BUREAU OF PLANNING AND ZONING

RE: **(23-002 LD Master Plan) – #23010007 – Martin Tower Complex *Revised* Master Plan Review – 1170 Eighth Avenue, Ward 13, Zoned OMU, Plans dated January 10, 2023.**

The EAC offers the following comments and recommendations based on the revised 2023 Master Plan.

Potential trail connections around Martin Tower site (CAT concept)

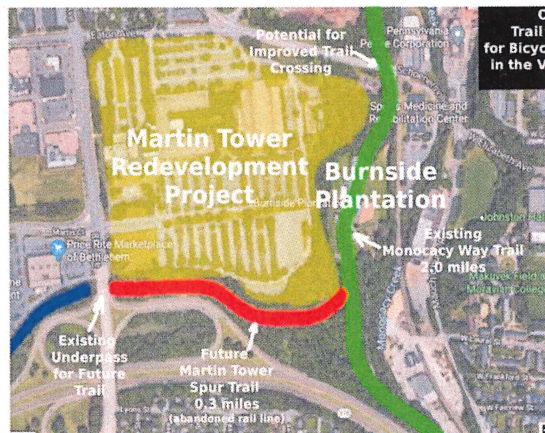
While a 2+ mile rail trail might seem ambitious out of the gate, a starting point with this project should be to connect the Monocacy Way trail to 8th Avenue, a 0.3 mile long section that follows the southern border of the Martin Tower project. (shown in red as Future Martin Tower Spur Trail" in the image to the right)
